**MAJOR PROJECT ASSESSMENT:  
Sydney Opera House - Stormwater Drain  
Diversion (MP09\_0122 MOD 1)**

Director-General's  
Environmental Assessment Report  
Section 75W of the  
*Environmental Planning and Assessment Act 1979*

October 2011

**Figure 2: Project Layout**

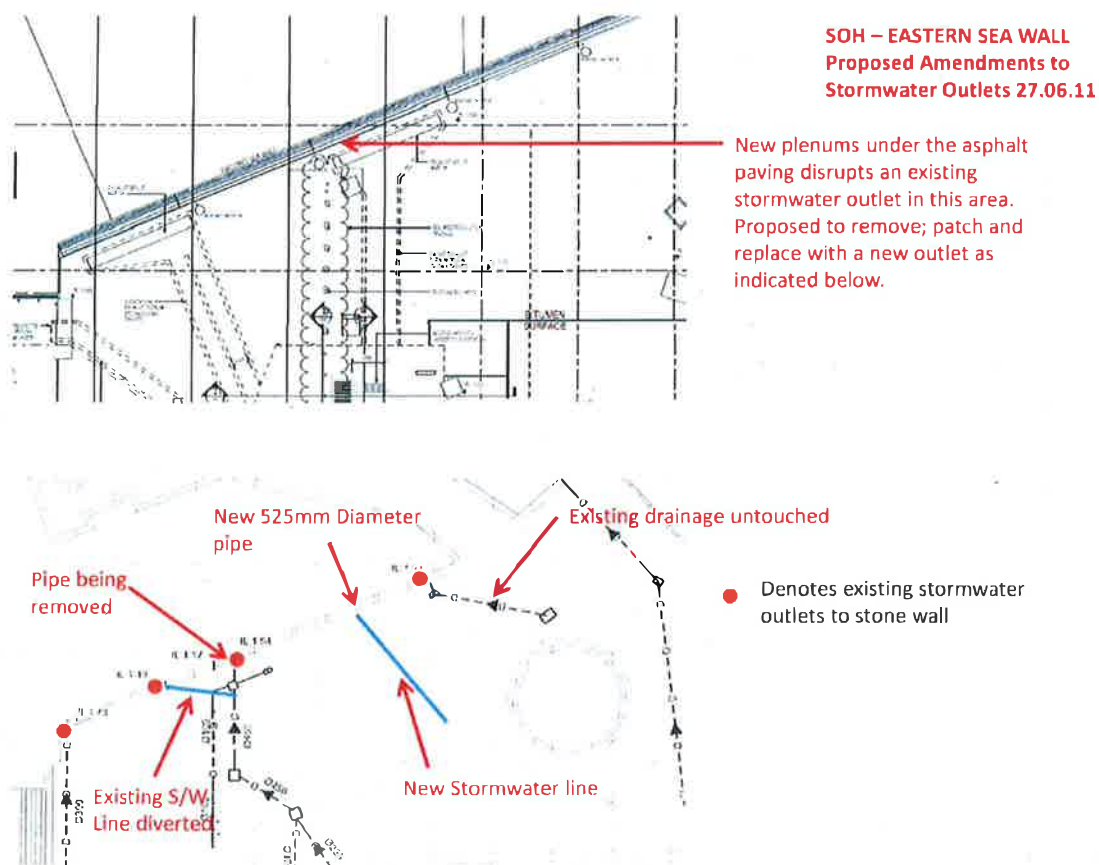
**Council of the City of Sydney (Tag B)** – considers the proposed outlet to be too large and visually intrusive at low tide, and has recommended that two smaller pipes and outlets be used in place of the proposed single pipe and outlet, and that these new outlets be well separated.

Council's suggestion of two smaller pipes instead of the one larger pipe was forwarded to the Proponent for their consideration. In response it has advised (**Tag I**) that the use of two smaller pipes was considered as an option but was dismissed for the following reasons:

The proponent has submitted supplementary engineering and heritage advice to justify the proposed single outlet and this has now been accepted by both Council and the Department. This is discussed in detail in section 5.2.

- Using two pipes would require a larger upstream pit which, in turn, would increase the footprint of the excavation works;
- The opportunity to significantly separate two smaller outlets is extremely limited because of the presence of the plenum located towards the Opera House, and the existing outlet located towards the Botanical Gardens; and
- The pipe and outlet immediately to the right of the proposed outlet is covered by an Easement in favour of the Opera House car park operators and they have denied permission to connect into this service because of the risk of flooding the car park.

- that the stormwater outlet can not be reduced in size through bifurcation;
- with the plugging specification for the making good of the sandstone; and
- with the archaeological impact assessment report prepared by Godden Mackay Logan.

The Department and Council are both satisfied that the single pipe option is a superior option to the suggested twin pipe solution.
